DFCM Addendum No.#001

Date: November 14, 2023
To: PRE-QUALIFIED GENERAL CONTRACTORS
From: GUY WAYMAN- DFCM PROJECT MANAGER
Reference: UDOT MURRAY TOW PLOW STORAGE BUILDING
DFCM Project #24096900

UDOT Murray Tow Plow Storage Building

Addendum #01

SHEET TITLE:
SITE PLAN / ROOF PLAN
SHEET NUMBER:
AS-101

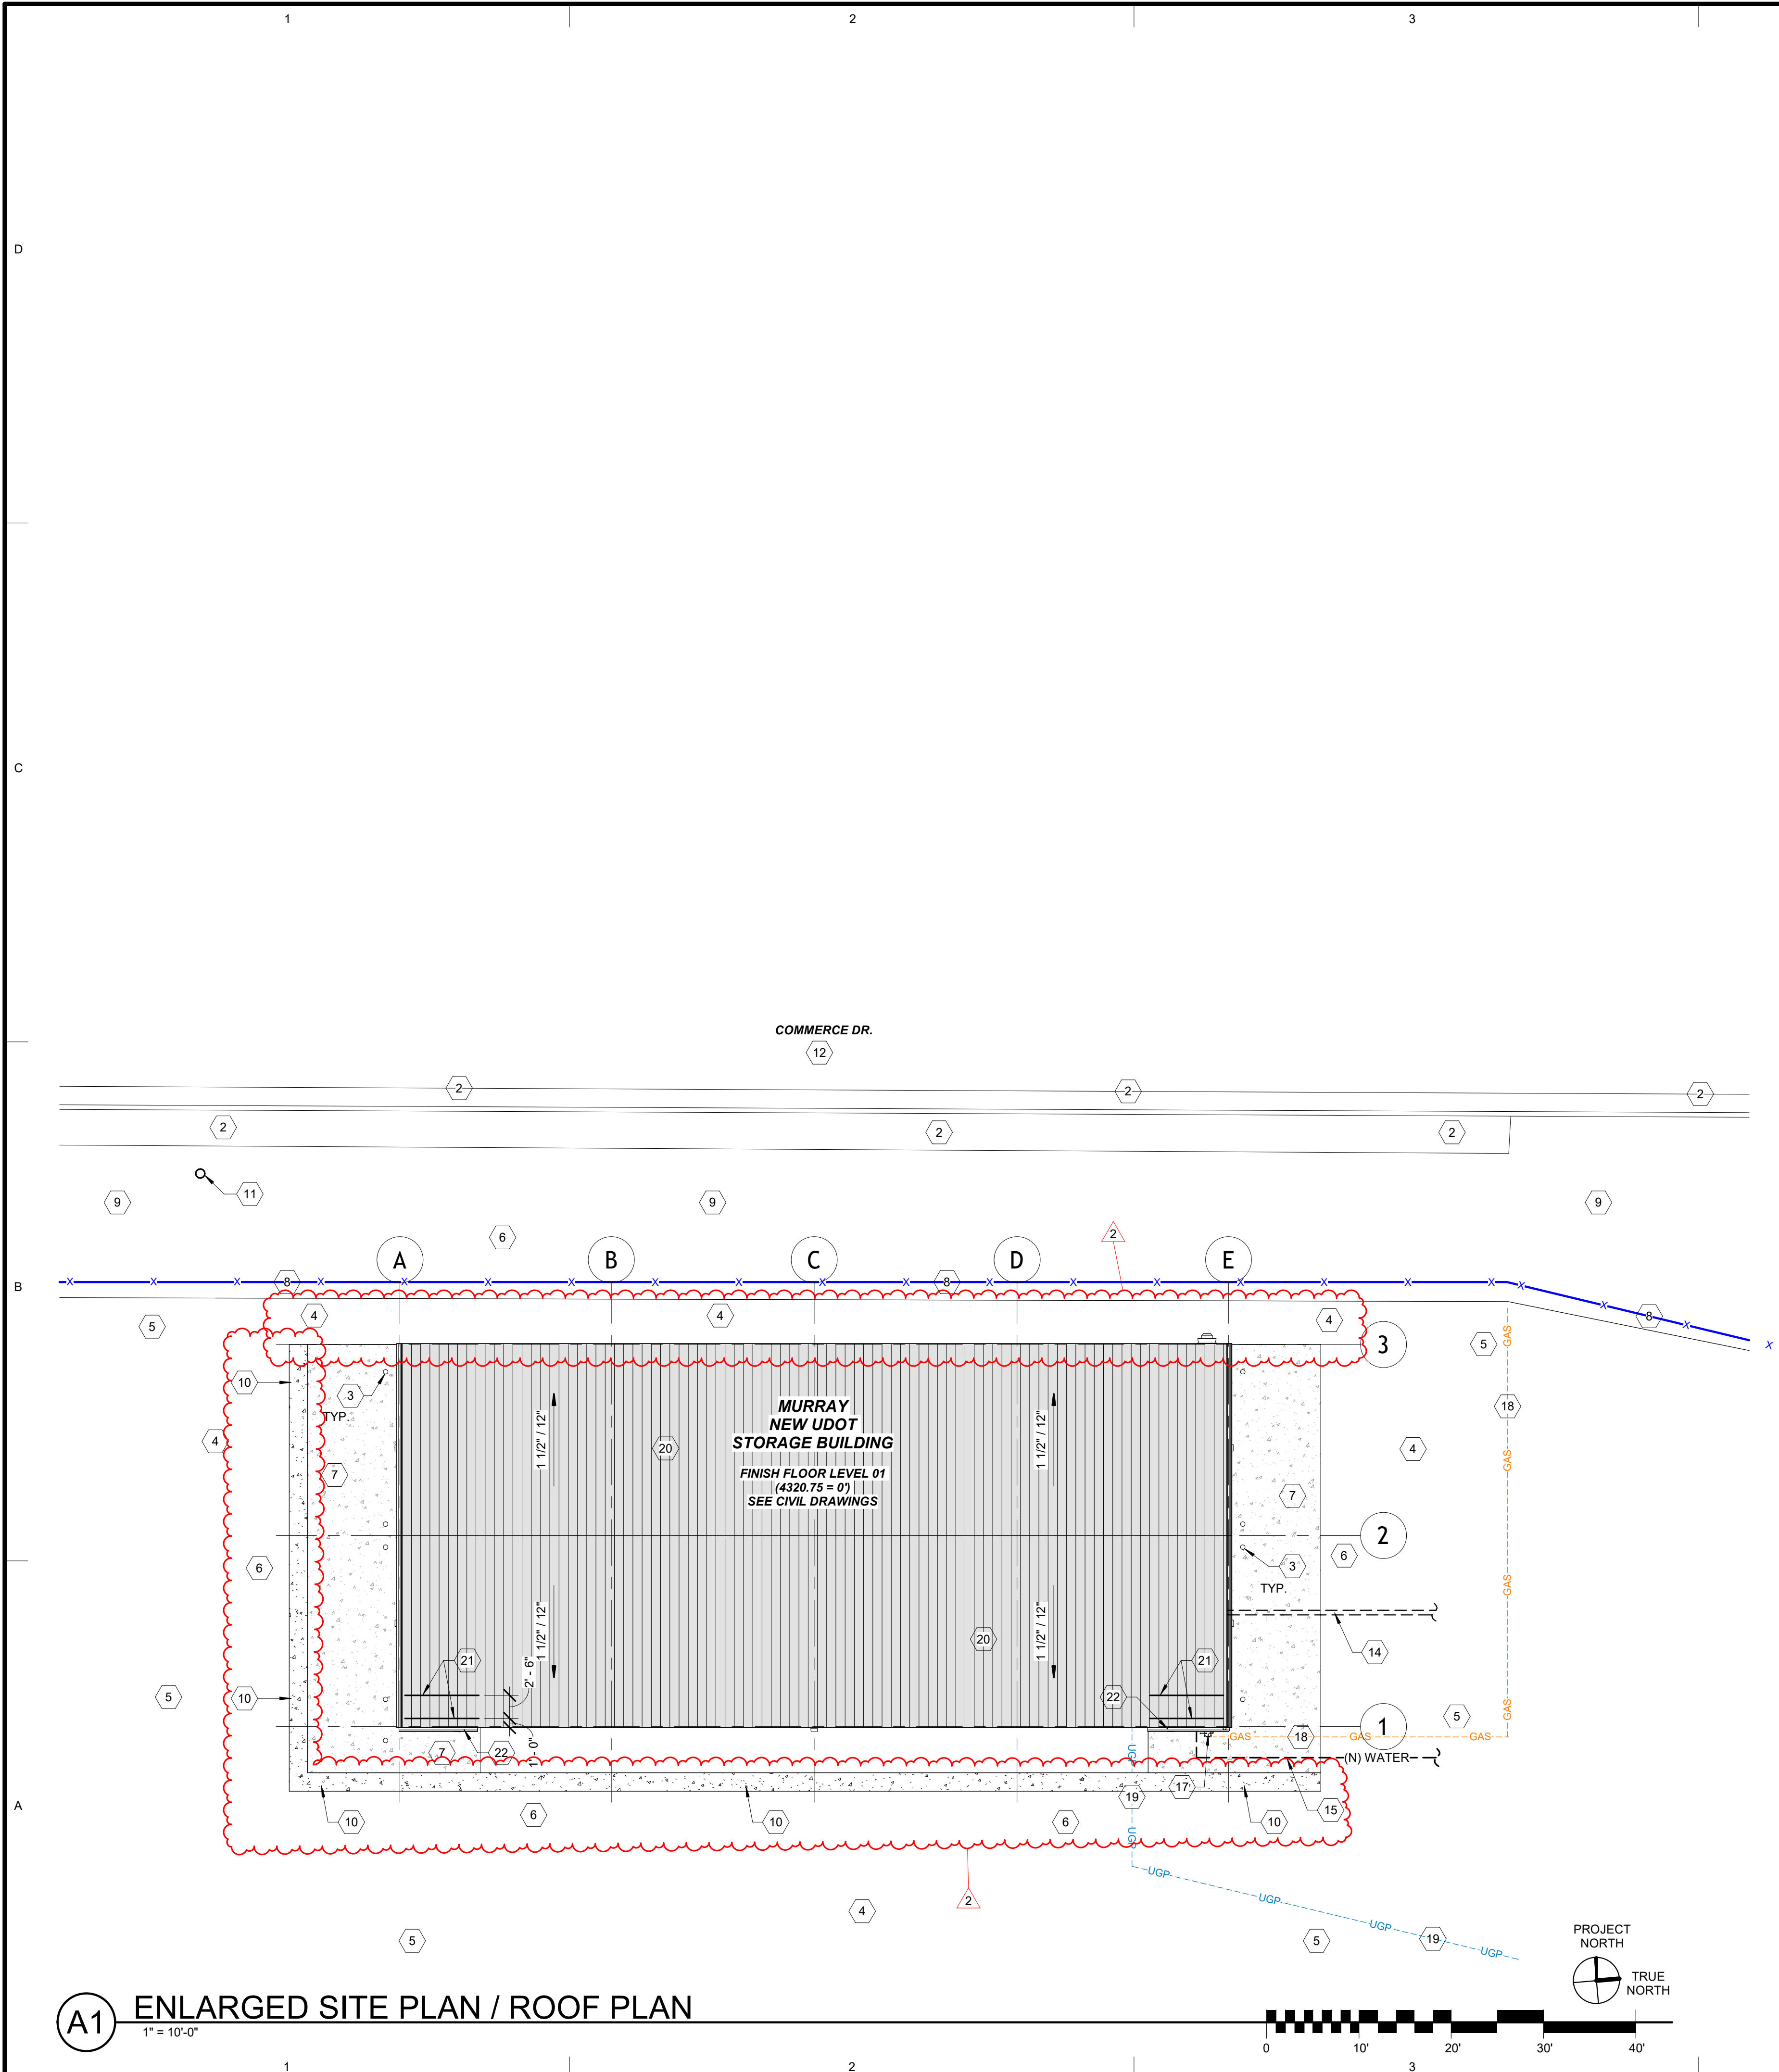
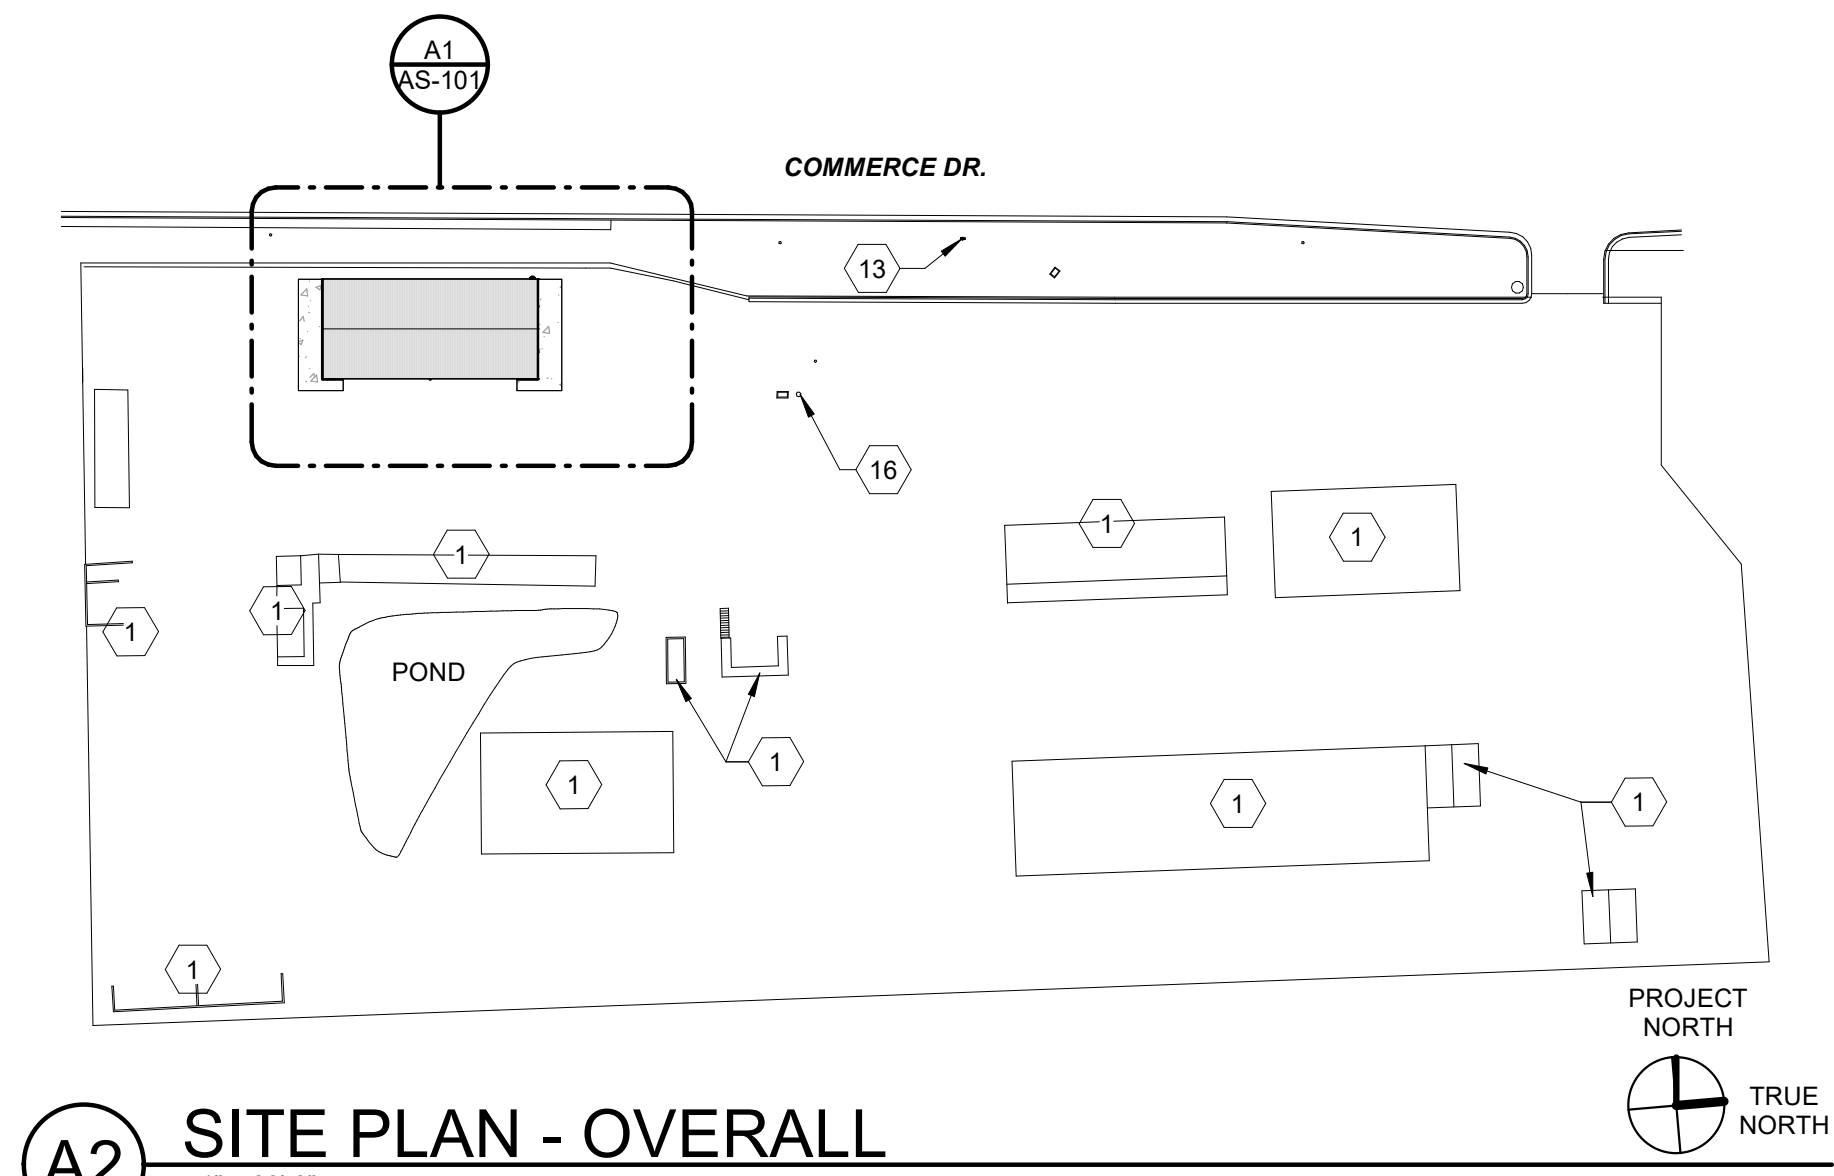
Q: On Plan Sheet CE-400, it calls out for a waterway (keynote C-5) but on Plan Sheet AS-101 there isn't a water way called. Is a waterway required?

A: See the revised AS-101 attached.

10. NEW CONCRETE WATERWAY - REFER TO CIVIL DRAWINGS.
11. EXTG. POWER POLE/STREET LIGHT TO REMAIN - PROTECT FROM DAMAGE - REFER TO ELECTRICAL DRAWINGS.
12. EXTG. ASPHALT ROADWAY TO REMAIN - PROTECT FROM DAMAGE.
